**Subject:** RE: Grenfell - Meeting attendees

I have now had an opportunity to visit the buildings we discussed in the meeting. Unfortunately, we remain unconvinced that the panels would provide a long term quality required for such a high profile building. Overall the buildings have a flat, almost dull, appearance. The fixings are clearly visible and on many of the panels. In some cases the fixings have not be aligned, resulting in a random and un-uniform appearance. In addition, many of the panels had not weathered well, with water damage and accumulation of dirt around ledges, pipes etc.

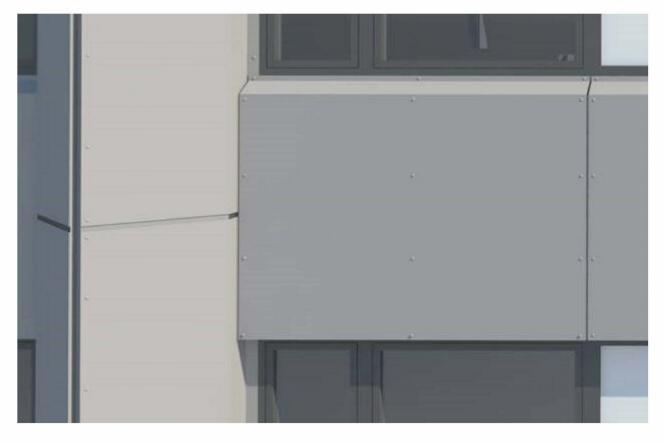
- She re-iterated the request for an finished example of a brushed appearance.
- She did only look at Chalcott Estate and conceded that the vast expanse of flat panel used there is unlike Grenfell.
- She is interested to see the detail and junctions: window head, window cill, and particularly the pilasters.
- She re-iterated the concern about the exposed fixings and the overall quality of appearance.

Sarah agreed with me that the visual interest of the interfaces/junctions will be important and it was in the back of her mind but not mentioned in the email. As such I would suggest a sample at least as big as the crop below.
